Addendum 9: Regulation No. 10**Revision 5**

Doc. Ref.	Reg. Status	UNECE document	Date EIF
Rev.5/Amend.1	Suppl. 1 to 05 series	WP29/2016/16	[8.10.16][IC1]

+ OICA proposals/comments as of 25.08.16. Modified § are in red. Added text is in bold, deletion is strikethrough. Not decided items are in brackets.

**Uniform provisions concerning the approval of vehicles with regard to
electromagnetic compatibility**

Figure 1c

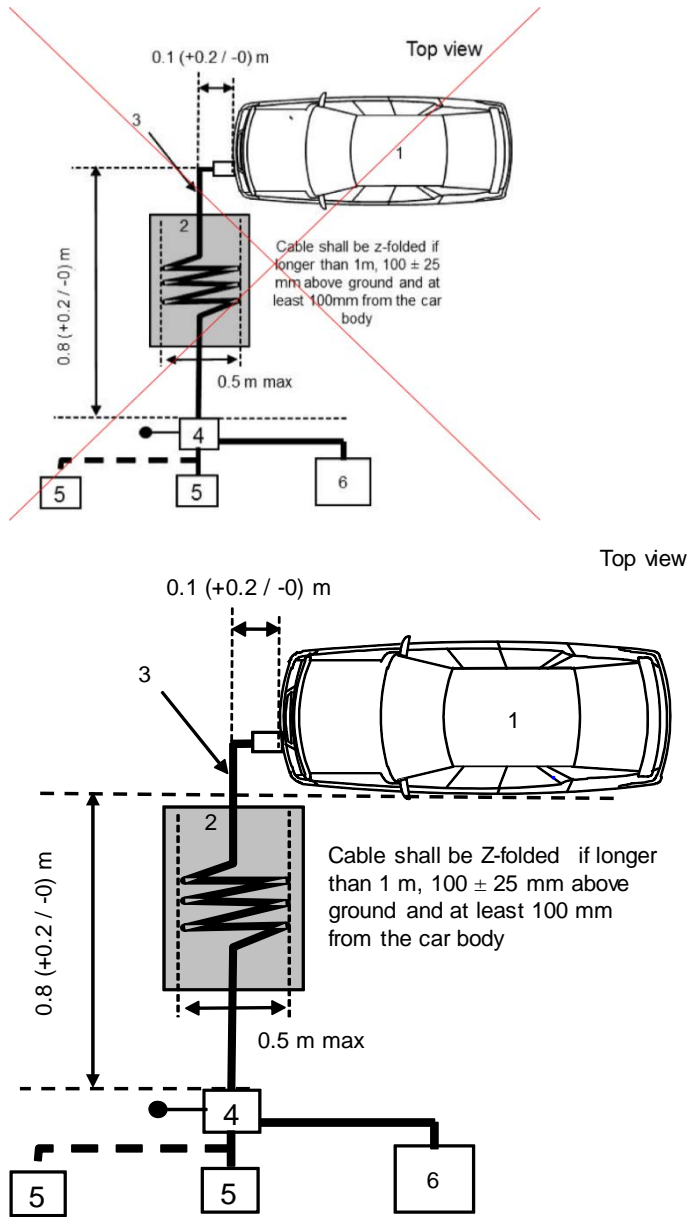
[IC68]

Figure 2a

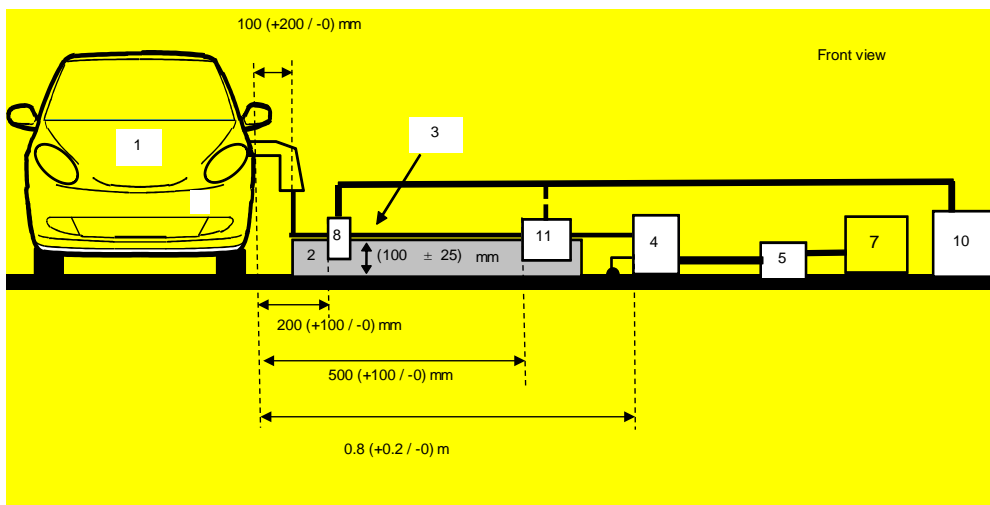
[IC77]

Figure 2c

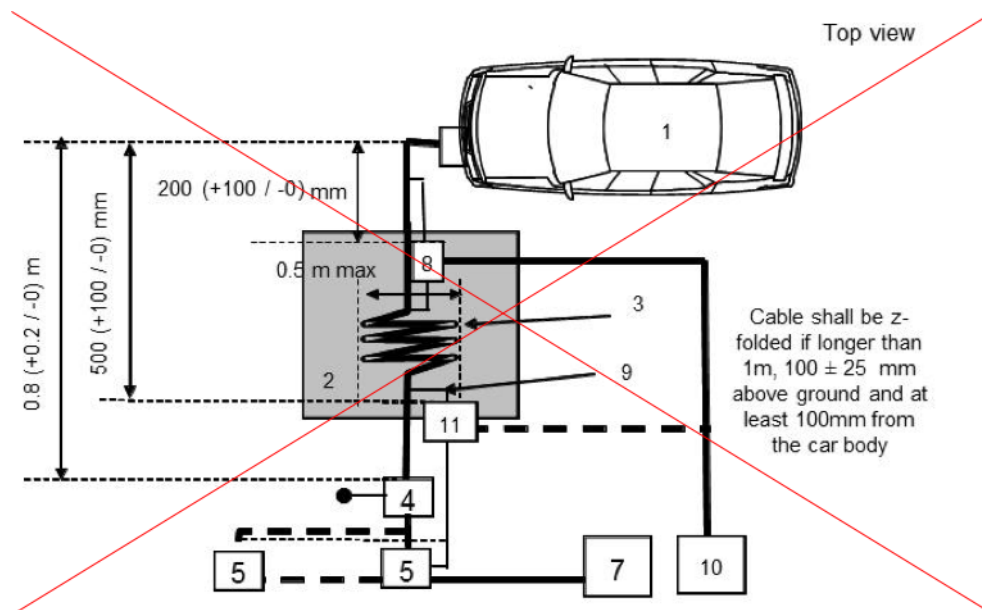
[IC78][IC79]
